U.S. Department of Energy
Office of River Protection

U.S. DEPARTMENT OF ENERGY (DOE), OFFICE OF RIVER PROTECTION (ORP)
SUBMITTAL OF CLOSURE REPORTS FOR SIX EMISSION UNITS IN THE HANFORD
SITE AIR OPERATING PERMIT (AOP), PERMIT NUMBER 00-05-006/LICENSE NUMBER
FF-01

Report of Closure for Emission Units

| 9. Title Isolate and remove 241-AW Primary Ventilation | 10. Bldg. / Facility No. 241-AW | 11. Equipment / Component ID AW Primary Ventilation System | 12. Approval Designator N/A |

H-2-90906, Sheet 1, Rev. 8 HVAC Equipment Plans Elevation and Details

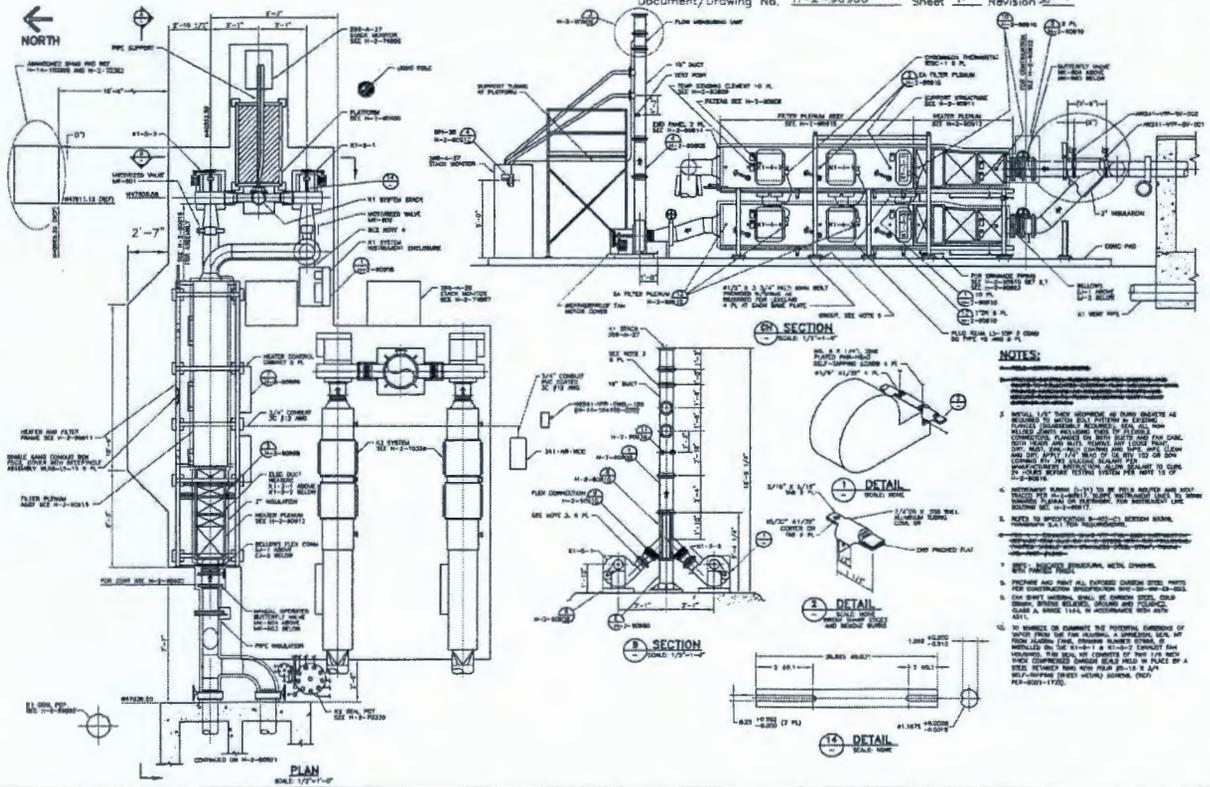
Revise drawing to show isolation and removal of the K1 system above grade. Seal pot, concrete pad and associated dimensioning are to remain. See pages 5 & 6 of this ECN.

IS: ECH NOTE: (DO NOT INCORPORATE)
SEAL POT, CONCRETE PAD AND ASSOCIATED
DIMENSIONING TO REMAIN.

H-2-90922, Sheet 1, Rev. 1 Piping Primary Exhaust Modification

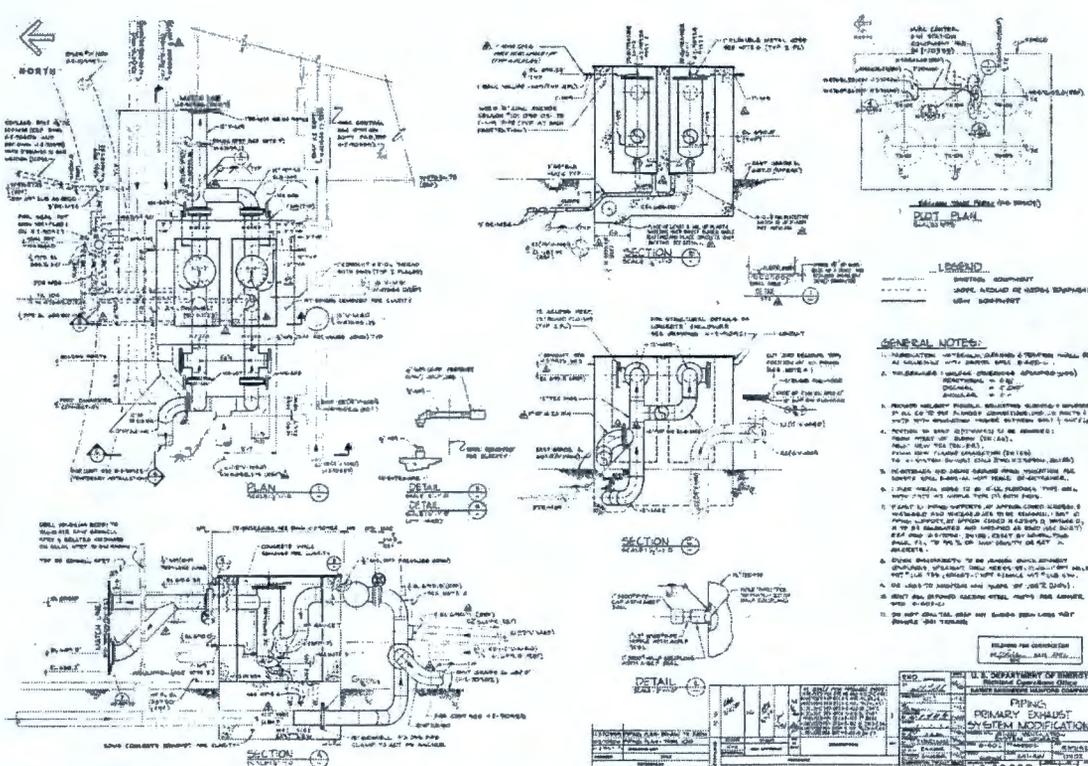
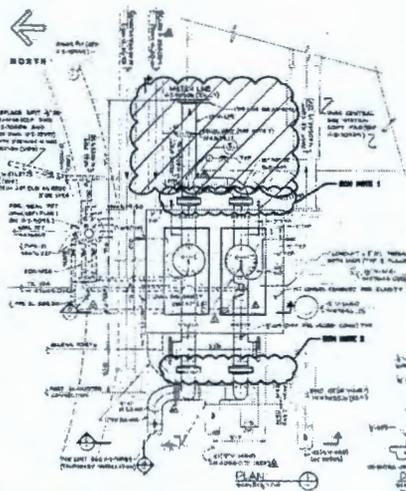
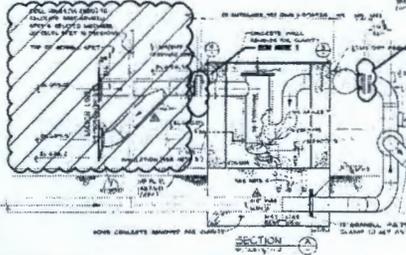
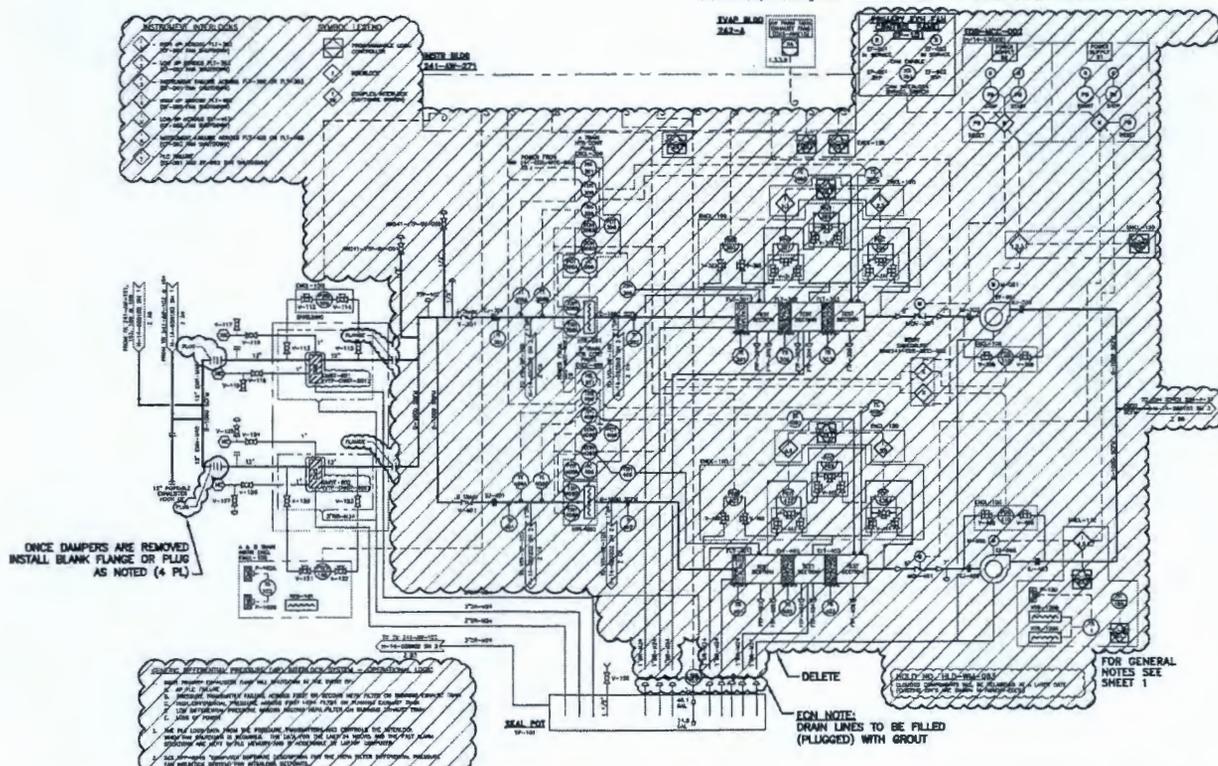
Revise drawing to show isolation and removal of the K1 system above grade and delete associated details. See pages 7 & 8 of this ECN.

- IS: EGN NOTES:
 1. ONCE DAMPERS ARE REMOVED, INSTALL BLANK FLANGE.
 2. ONCE DAMPERS ARE REMOVED, INSTALL BLANK PLUG.

H-14-020102, Sheet 2, Rev. 14 AW VTP P&ID

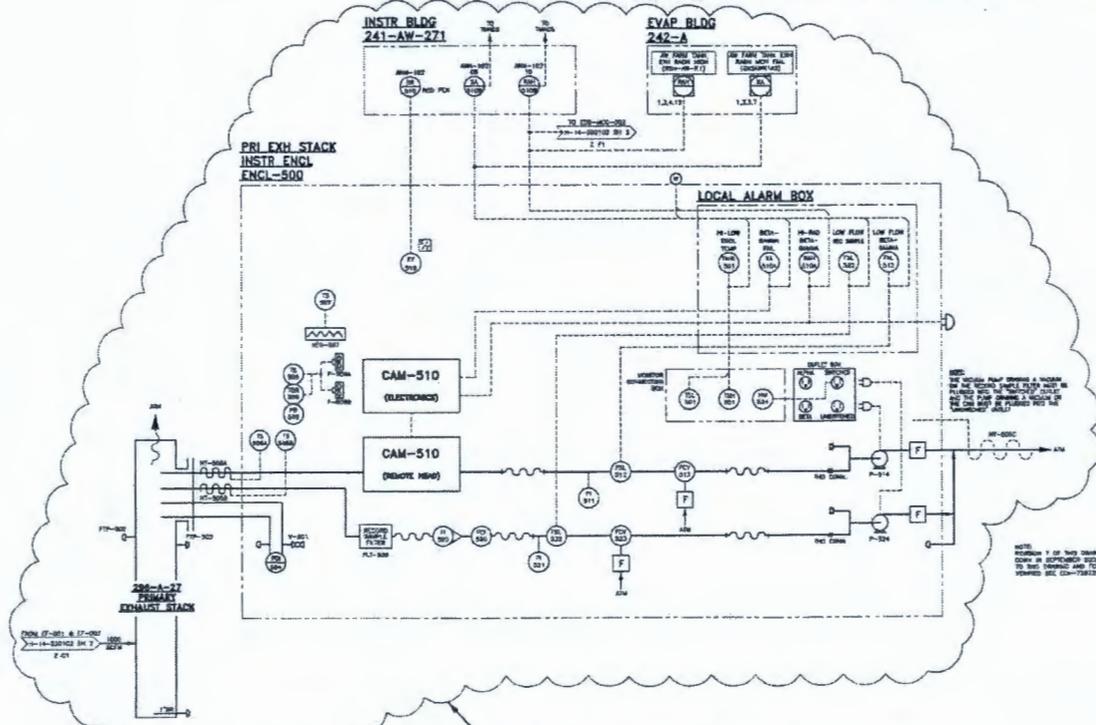
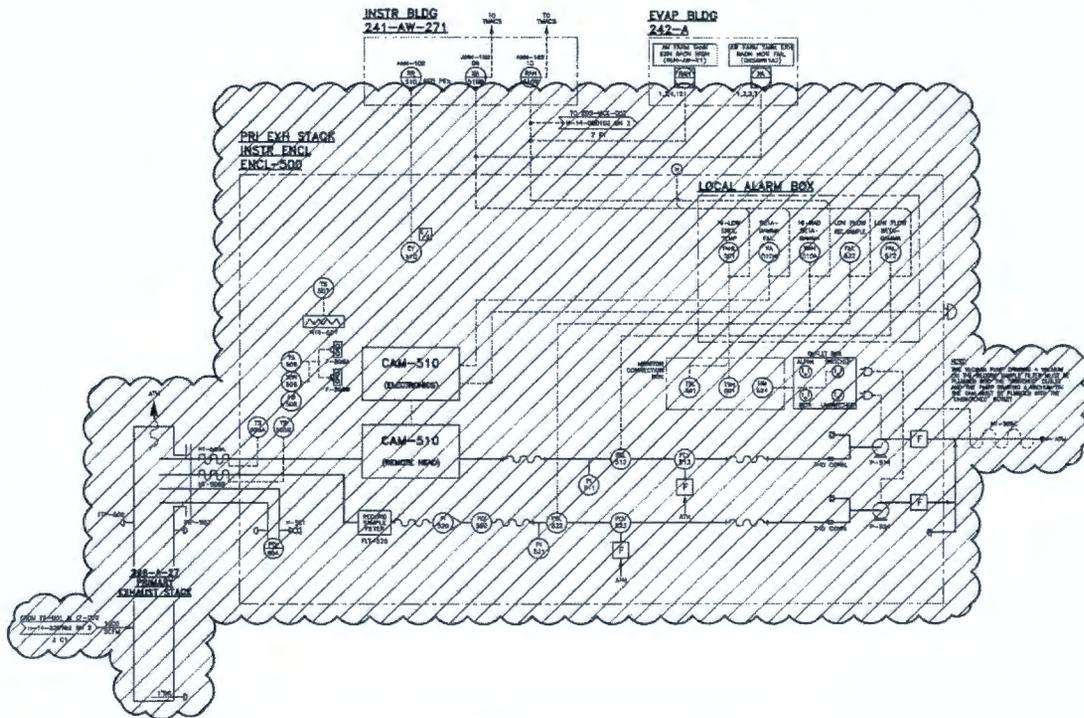
Revise drawing to show isolation and removal of the K1 system. Associated piping to be cut and capped at grade. See pages 9 & 10 of this ECN.

H-14-020102, Sheet 3, Rev. 7 AW VTP Stack Monitor P&ID

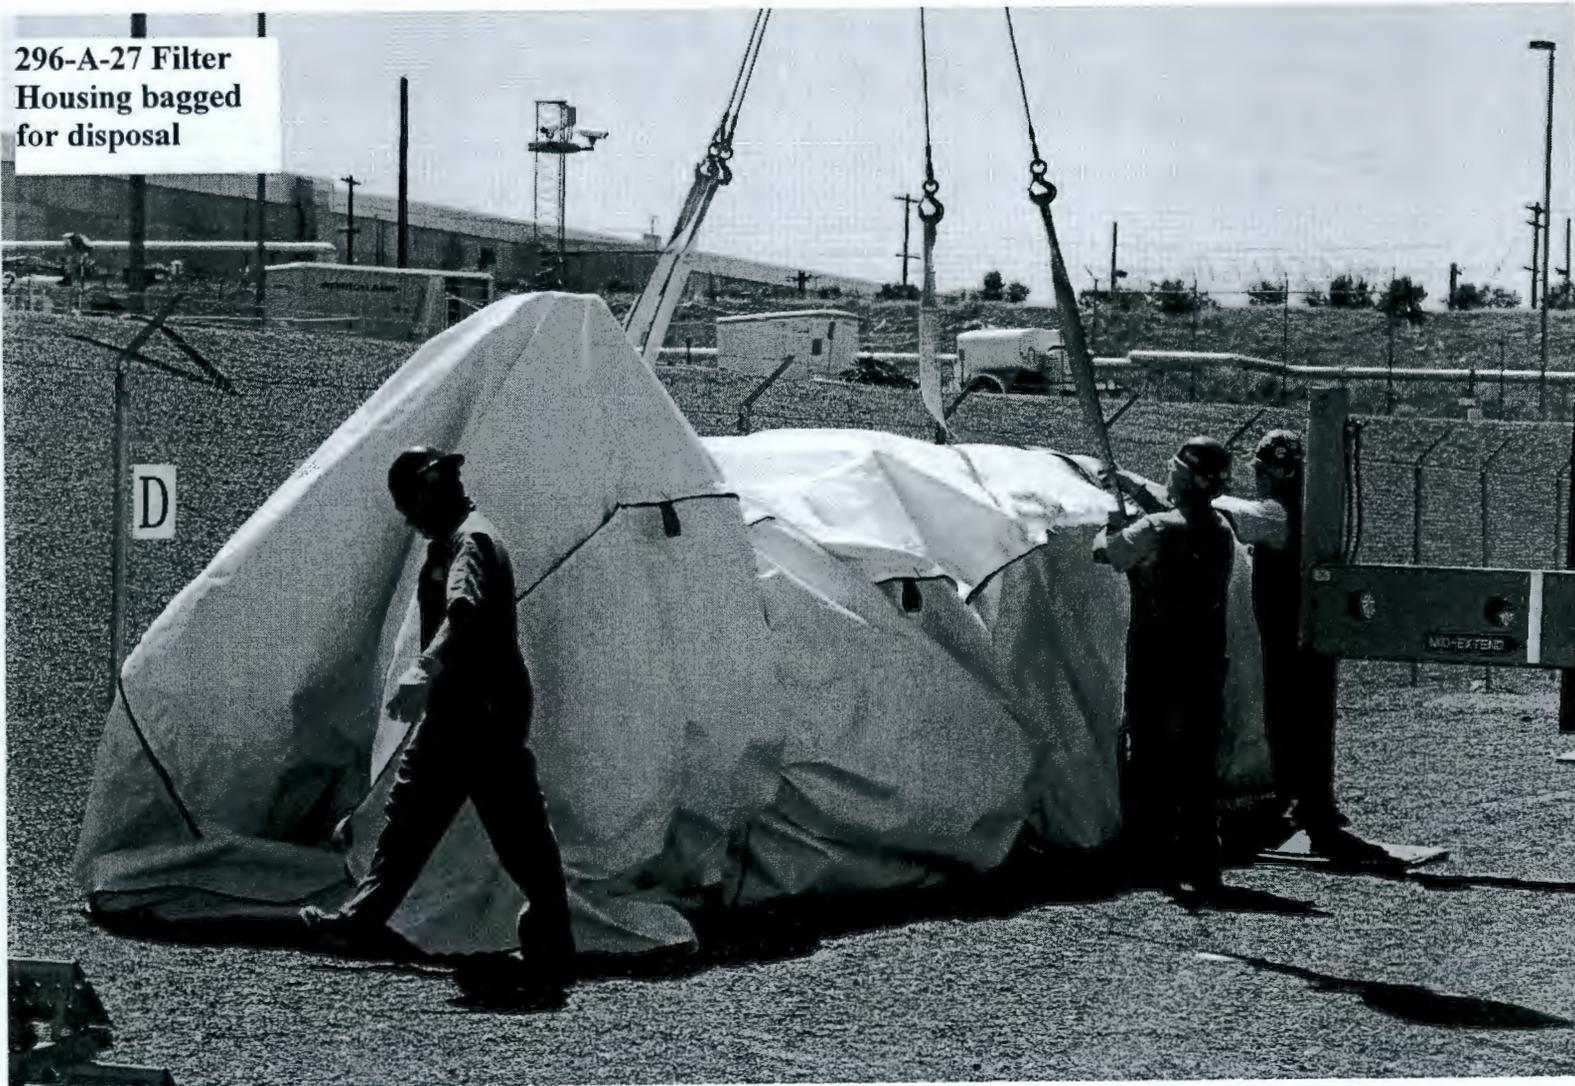
Revise drawing to show isolation and removal of the K1 system. See pages 11 & 12 of this ECN.

H-14-030013 Sh. 9, R. 6

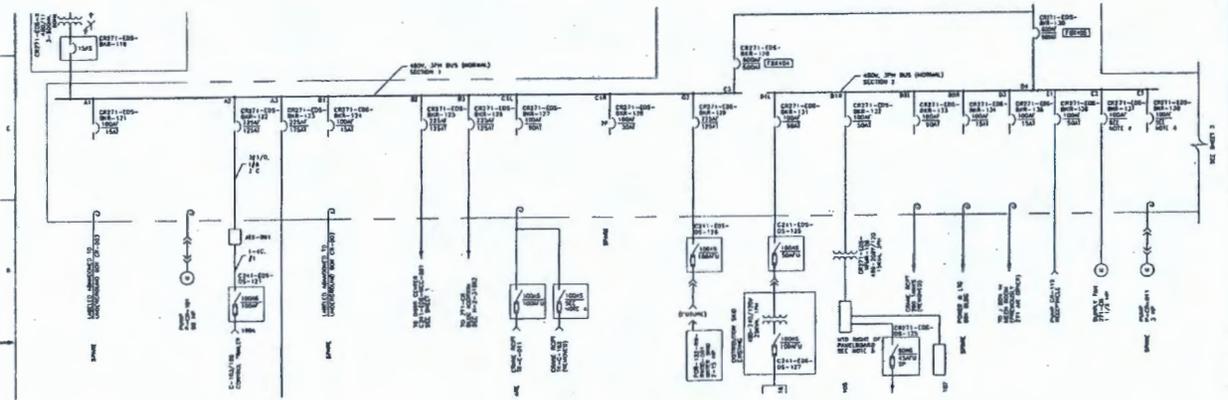
Revise panelboard schedule to show circuits 25, 29, and 31 as spare and update load values as shown on page 7.

Document/Drawing No. H-14-030013 Sheet 2 Revision 9

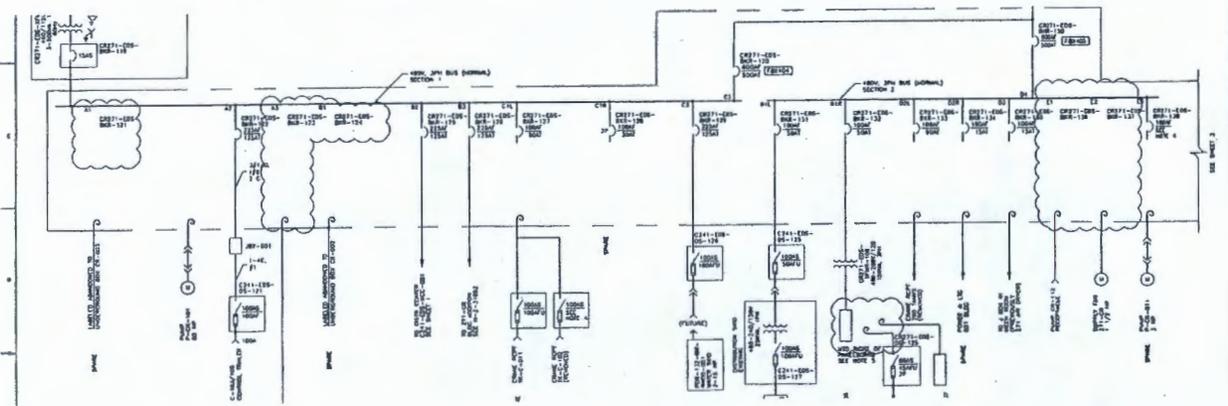
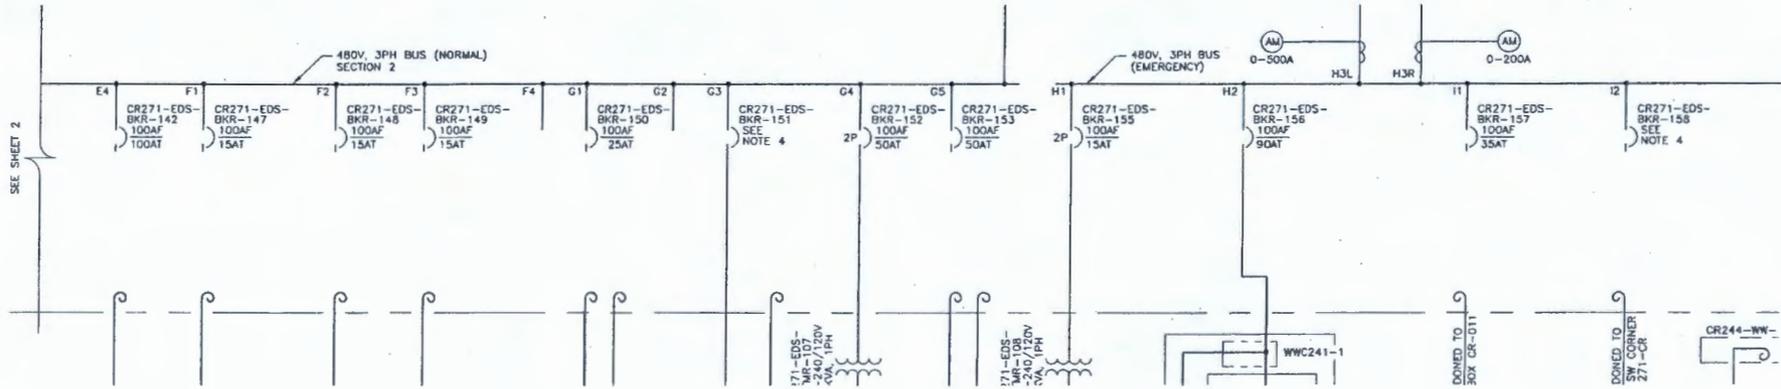
IS: REMOVE BREAKERS AND DISCONNECT EQUIPMENT SHOWN

Document/Drawing No. H-14-030013 Sheet 3 Revision 6

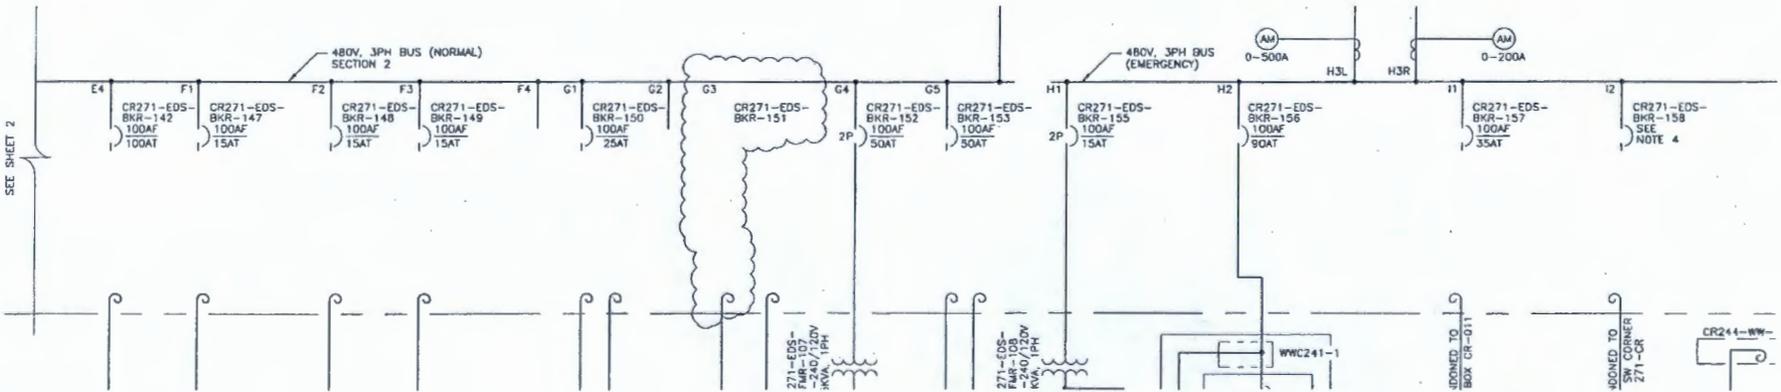
IS: DISCONNECT EQUIPMENT AND REMOVE BREAKER AS INDICATED

Document/Drawing No. H-14-030013 Sheet 3 Revision 6

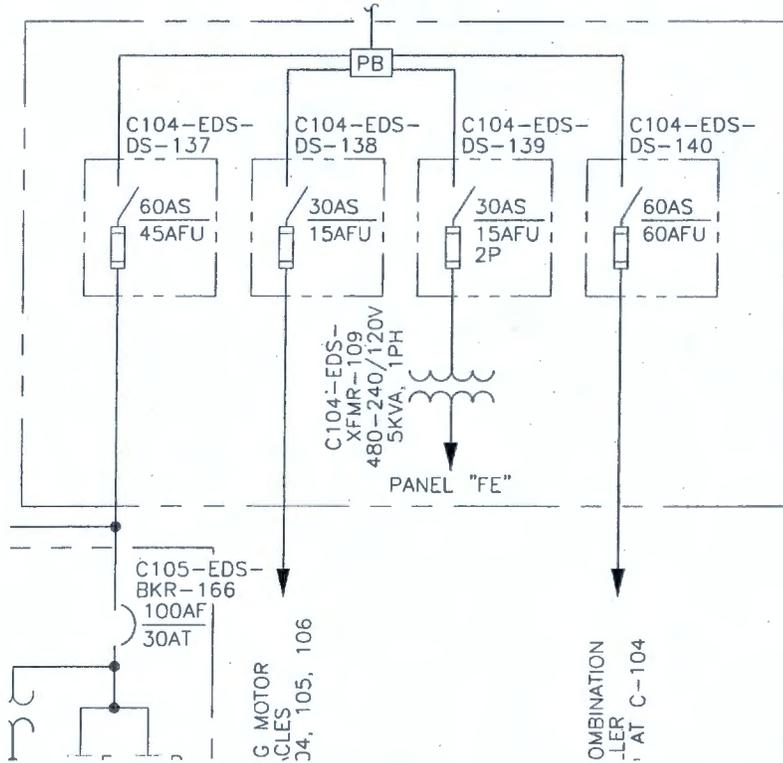
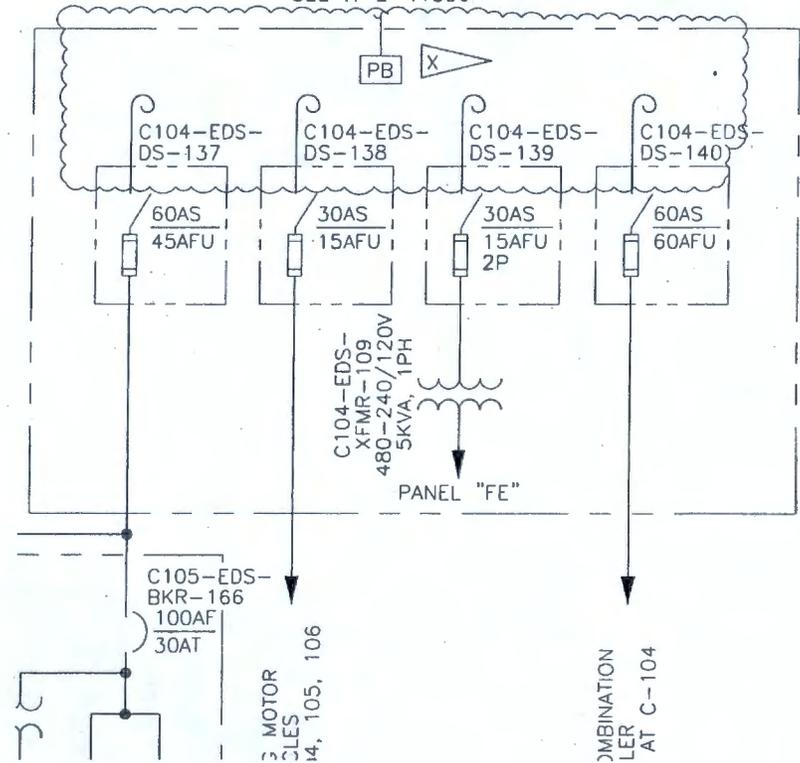
The disconnection of the disconnect switches from the pull box (PB) as shown on sheet 6 of this ECN are to ensure the power is isolated to the disconnects to allow removal from the EDS preventative maintenance data sheet. Due to the lack of space the wires shown coiled outside the box is solely for the clarity of the disconnection. A flag note "X" to be added as the next available note on the drawing will state the following:

NOTE "X." WIRES ARE DISCONNECTED AND SAFED OFF INSIDE THE PULL BOX.
